Contract #: 04-0120F4Cty: SF/ALA Rte: 80 PM: 13.2/13.9File #: 69.25B**QUALITY ASSURANCE -- NON-CONFORMANCE REPORT****Location:** Changxing Island, Shanghai, P.R. China**Report No:** NCR-000479**Prime Contractor:** American Bridge/Fluor Enterprises, a JV**Date:** 15-Oct-2009**Submitting Contractor:** Zhenhua Port Machinery Company, Ltd (ZPMC), Changxing Island**NCR #:** ZPMC-0452**Type of problem:****Welding****Concrete****Other****Welding****Curing****Procedural****Bridge No:** 34-0006**Joint fit-up****Coating****Other****Component:** 5AE Bike Path Cantilever Brackets BK1 @ PP29**Procedural****Procedural****Description:** Visual Cracks on Bike Path Cantilever Brackets**Reference Description:** Visual Cracks found on fillet welds of Bike Path Cantilever Brackets on 5AE PP29**Description of Non-Conformance:**

**Job Name:** SAS Superstructure

**Subject:** NCR No. ZPMC-0452

**Reference Description:** Visual Cracks found on fillet welds of Bike Path Cantilever Brackets on 5AE PP29

Component: 5AE Bike Path Cantilever Brackets BK1 @ PP29

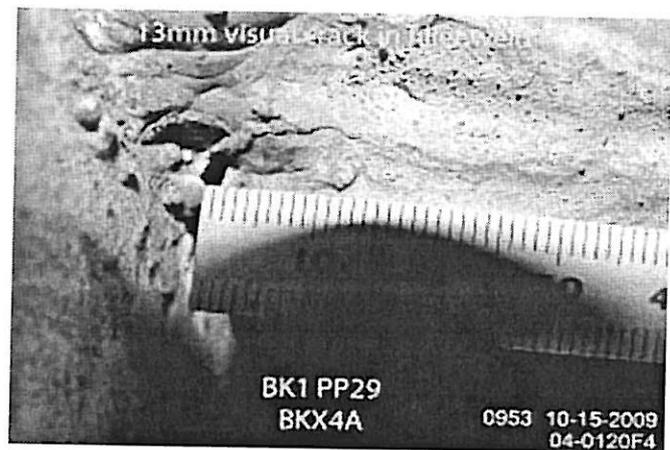
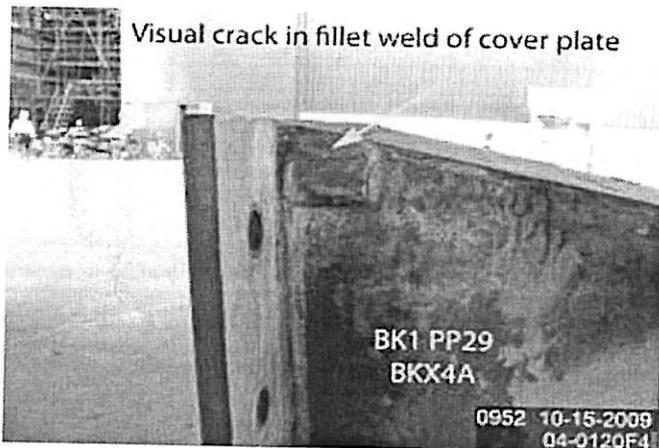
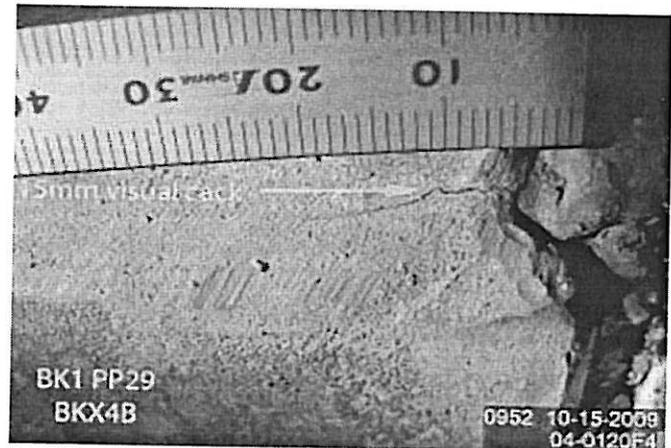
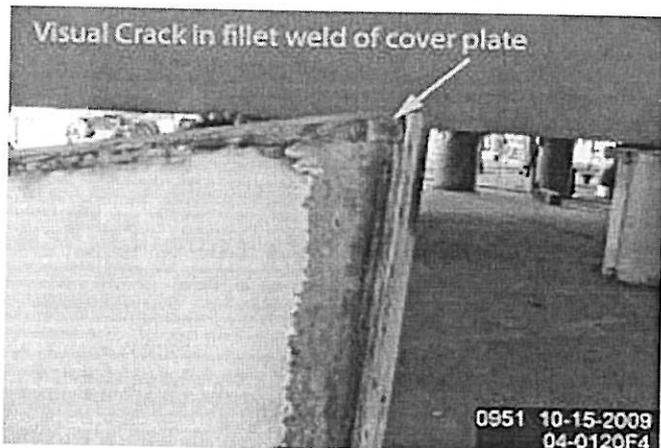
During a random visual inspection of OBG Segment 5AE Bike Path Cantilever Brackets (BK1), Caltrans Quality Assurance (QA) Inspector discovered visual cracks in the fillet welds on the top cope hole cover plates BKX4A and BKX4B at panel point 29. The visual crack observed on BKX4A measured 13mm in length and 15mm in length on BKX4B.

AWS D1.5-2002 Section 6.26.1.1; The weld shall have no cracks.

Repair said indications and perform NDT required to verify weld quality

The Department issued NCR ZPMC-466 in regards to ZPMC personnel performing repairs without prior approval of the Engineer. Contractor submitted NDT report verifying the welds are now in conformance with Contract specifications.

**Component:** OBG Lift 5E Cantilever Bike Path Bracket

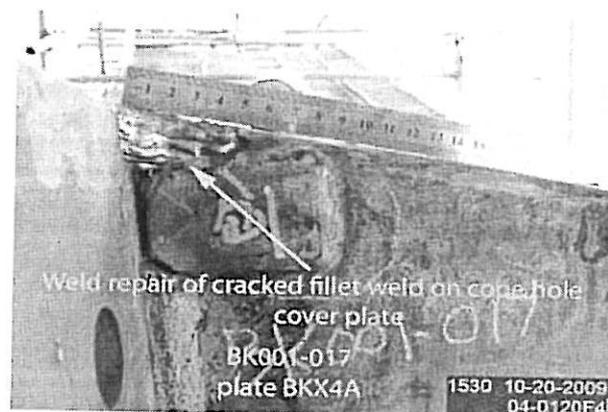
During random visual inspection the Caltrans Quality Assurance (QA) Inspector observed weld repairs were performed on cracks in the fillet welds on the top cope hole cover plates on plates BKX4A and BKX4B of BK001-017. Carbon air arc gouging was used to remove the cracks. NDT was not performed on the excavated area to insure the defect was completely removed. The weld repair was performed with the Flux Cored Arc Welding (FCAW) process. The fillet welds of the cover plate do not have a designated weld numbers for identification. These repairs were performed without an approved welding procedure and the Engineer's approval. These cracks were found on Oct 15, 2009. (see NCR ZPMC-0452)

"The Engineer shall be notified immediately in writing when welding problems, deficiencies, base metal repairs, or any other type of repairs not submitted in the WQCP are discovered and also of the proposed repair procedures to correct them. For requests to perform repairs, the Contractor shall include an engineering evaluation of the proposed repair. The engineering evaluation, at a minimum, shall include what is causing the
